MEETING NOTES

TO: Distribution **DATE:** April 6, 1994
FROM: Philip Nixon **PROJECT:** Solar Pond IM/IRA
MEMO #: SP307 040694 01

SUBJECT Weekly Status Meeting

1) Building 788

Figure 3 1

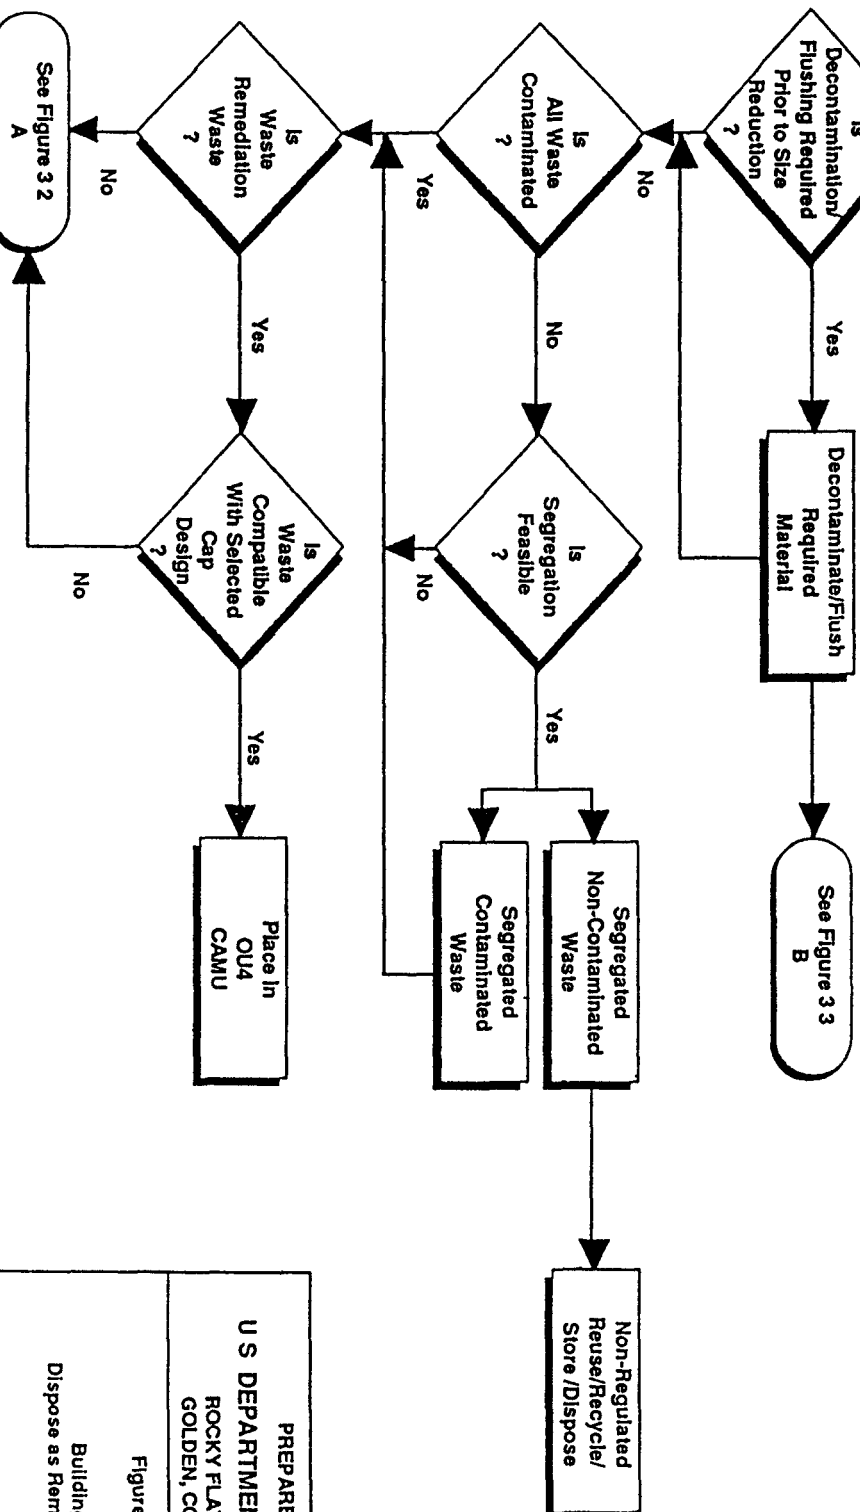
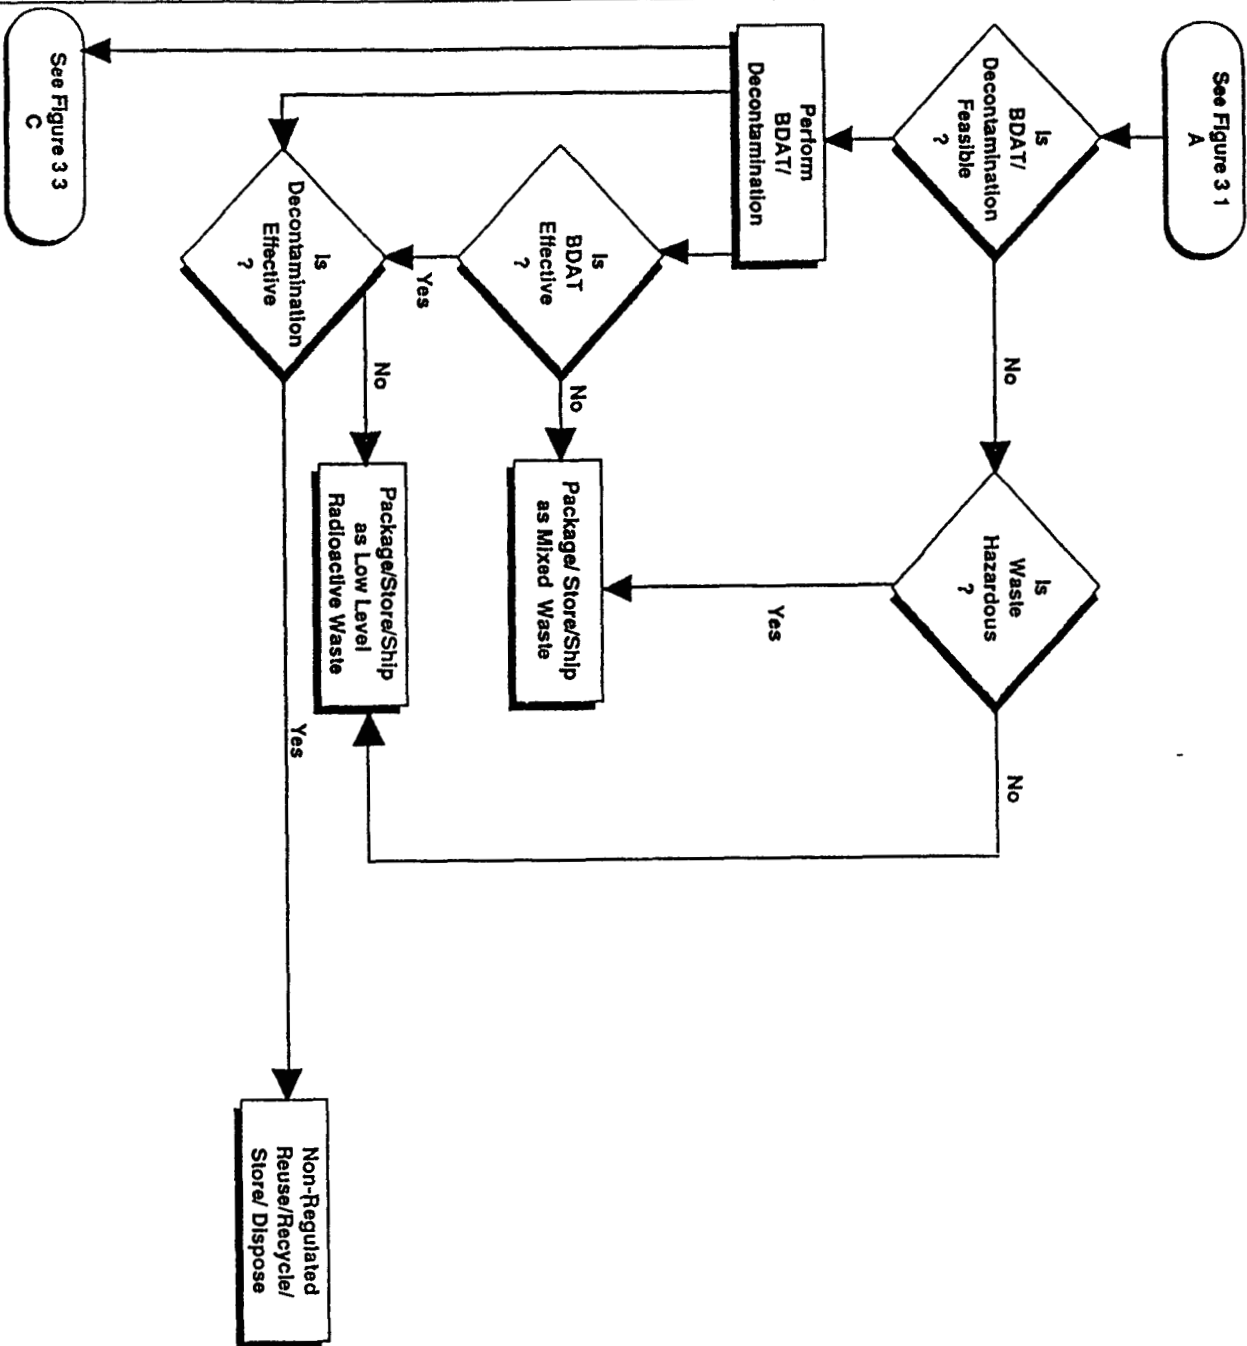
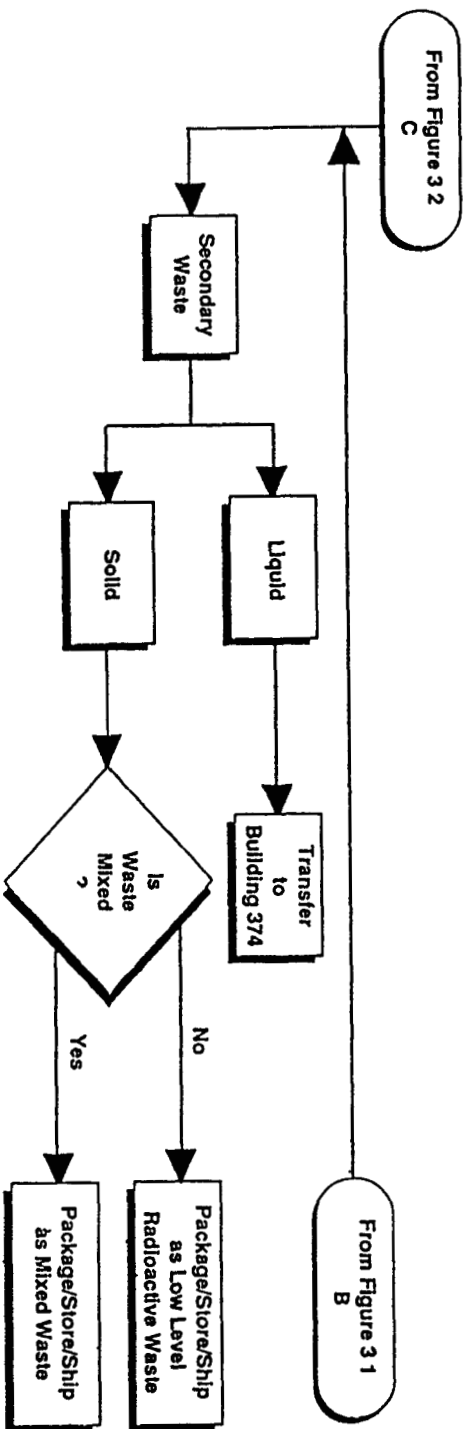
CDH questioned whether the disposition of the materials beneath the engineered cover within the CAMU was allowable. The materials could be dispositioned within the CAMU if the wastes were designated remediation wastes as opposed to newly generated wastes which typically result from RCRA closures.

It was decided that the proposed alternative would be acceptable from a regulatory point of view if the following flow diagram provided affirmative answers (see next page)

The key to resolving the issue concerning the disposition of Building 788 materials will be the determination of whether the materials are considered remediation waste. The following rationale were discussed with respect to why the wastes may be considered remediation wastes
